**Revision to a Request for Supply
Arrangement - Révision à une demande
pour un arrangement en matière
d'approvisionnement**

Title - Sujet Furniture for Work Spaces	
Solicitation No. - N° de l'invitation E60PQ-140003/A	Date 2015-08-05
Client Reference No. - N° de référence du client E60PQ-140003	Amendment No. - N° modif. 022
File No. - N° de dossier pq416.E60PQ-140003	CCC No./N° CCC - FMS No./N° VME
GETS Reference No. - N° de référence de SEAG PW-\$\$PQ-416-66821	
Date of Original Request for Supply Arrangement 2015-02-19 Date de demande pour un arrangement en matière d'app. originale	
Solicitation Closes - L'invitation prend fin at - à 02:00 PM on - le 2015-08-27	Time Zone Fuseau horaire Eastern Daylight Saving Time EDT
Address Enquiries to: - Adresser toutes questions à: Clouthier, Chantal	Buyer Id - Id de l'acheteur pq416
Telephone No. - N° de téléphone (819) 956-7184 ()	FAX No. - N° de FAX () -
Delivery Required - Livraison exigée	
Destination - of Goods, Services, and Construction: Destination - des biens, services et construction:

This amendment is raised to answer questions and modify the solicitation as follows:

Historic panel configuration:

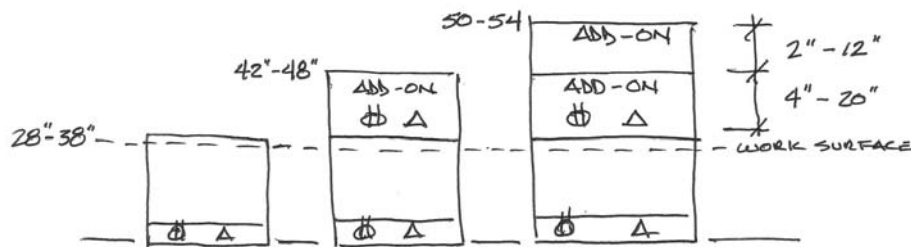
The definition of stack as it applies to the desk height privacy and seated height privacy continues to be a contentious issue.

All major systems furniture tender over the last couple of years (5000 plus WP 2.0 stations) were based on a "base panel" of approx 42-44 "with desk height power and comm. plus a seated privacy of 50-54" that included the base panel plus an add-on.

This new SA configuration with a base panel of 28" to 38" plus multiple add-ons is very different. The requirement to stack from this very low base panel is problematic in that the add-on elements can become very small (as little as 4"-8" high) and will not accommodate power and communications. This also becomes an expensive solution in that the vast majority of demand is for seated privacy and as such must be made up of a base panel plus 2 add-ons.

Additionally the current specification (3.12) requires all add-ons to be load bearing. Most manufacturers only allow the first add-on to be load bearing.

A base panel height of 28"-38" has very limited use. It could be used in perimeter applications but is not necessary given the addition of freestanding elements under the SA. Desking products would also negate its requirement.

This specification for Annex A-1, Work Spaces, supports the furniture requirement for the four worker profiles found in general purpose office space as detailed in the latest Government of Canada Workplace 2.0 – Fit-up-Standards – 2012. Category 1 - Interconnecting Panel System must be flexible to accommodate the design of spaces for “Fixed, Flexible and Free Address” worker. In order to achieve our mandate we require panel heights as stated in Annex A-1 article 3.4. Please refer to section 2 – modifications of this amendment.

INSERT: 6.2 Work Surface Privacy Height and Seated Privacy Height must be Stackable Panels and must consist of a Base Panel Height plus one or more Panel Add-on Modules. As part of the stackable panel each add-on module must be load bearing and provide hang-on capability.

Note: The total height of a Seated Privacy Height panel can be achieved with a Base Panel Height and one Panel Add-on Module, and does not exceed 1372mm (54") high.

Proposed panel configuration:

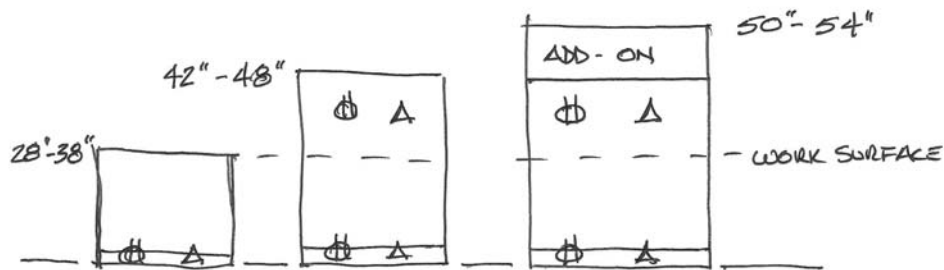
So as to include a larger selection of manufacturers in the systems furniture category 1, the description around panel height must be addressed.

The most effective solution would be to keep the current panel heights of 28" to 38", 42" to 48" and 50" to 54".

The 42" to 48" could accommodate base or desk height power and communications. The 50" to 58" height panel would be made up of a 42" to 48" base panel plus an add-on.

This would allow substantially all suppliers to qualify, reduce overall costs while still allowing flexibility.
